September 5, 2018

Re: Paradise Valley East Lincoln Drive South Development Area Work Session – Sept. 13
Major Special Use Permit Amendment (SUP-18-05) - Smoke Tree Resort
Major Special Use Permit Amendment (SUP-18-06) - Lincoln Medical Plaza
Effect on Adjacent Residential Properties

EXHIBIT B

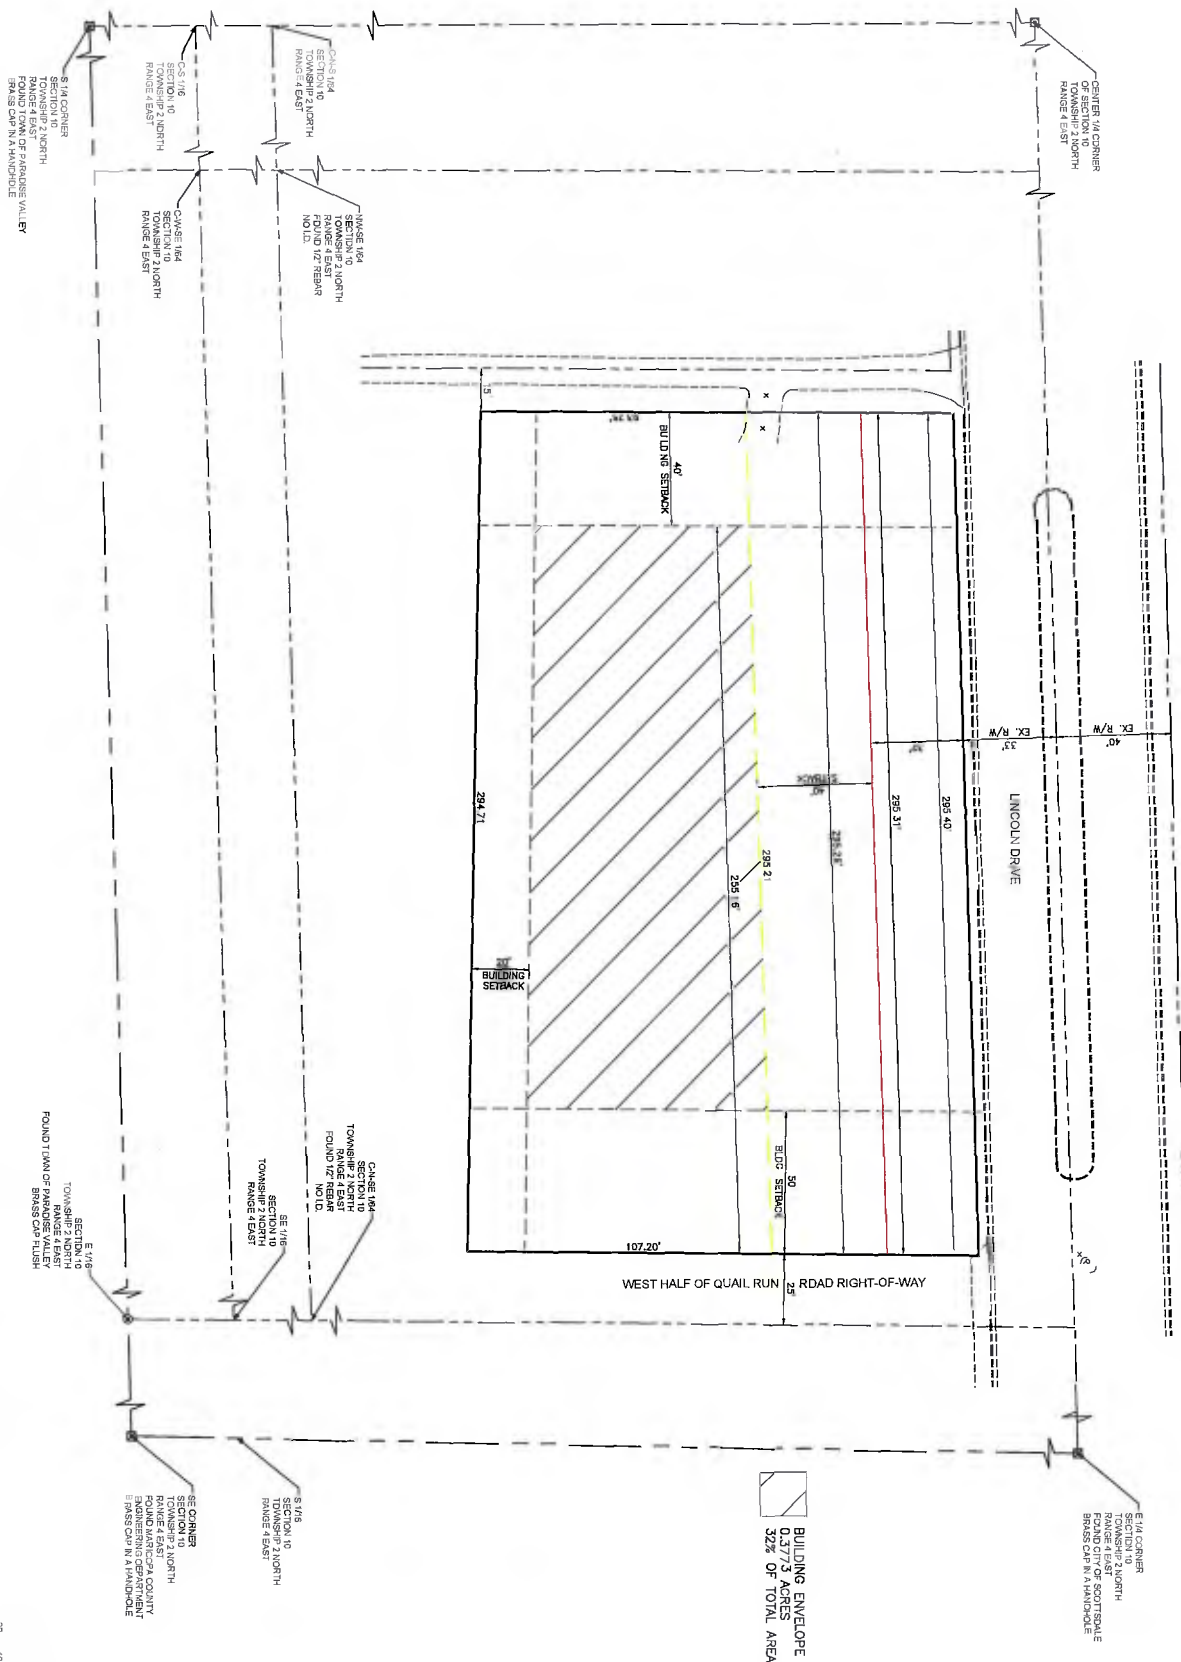
It's understood that Smoke Tree has resisted proposed changes to the existing access points and dedicating anything for streets as effectively shrinking the developable area of its property. In contrast, please see the diagrams attached as Exhibit B and Exhibit C and consider the impact on the neighboring residential property. Exhibit B depicts the current setback situation on the SunChase lot at the southwest corner of Lincoln and Quail Run. That lot is currently improved with a single-family home that is set back 52 feet from the existing Lincoln right-of-way. Exhibit C then depicts how the developable area of that lot is reduced by a number of potential additional setbacks that would impact any new construction. (1) The currently proposed Lincoln widening is an additional 32 feet (20 feet from the current residence). (2) Depending upon whether a new residence faced Lincoln or Quail Run, the front or side yard setback would be at least 40 feet from the widened Lincoln. (3) In either orientation, there is a recorded 50 feet setback required from Quail Run. (4) And in either orientation, there is another 40 feet setback from the rear and a 20 feet setback on the remaining side. (5) After the above points 1-4, the developable area that is left could be approximately $\frac{1}{3}$ acre, for an R43 zoned lot. Now, consider the exacerbating effect that along with Smoke Tree's proposal to further burden the half-street Quail Run, but not to dedicate its 25 feet, and to improve its property within that non-dedication area, it proposes to add two access points there. So, again, SunChase would like to know what the Town can do and proposes to do to address or otherwise protect the existing residential neighborhood adjacent to Smoke Tree.
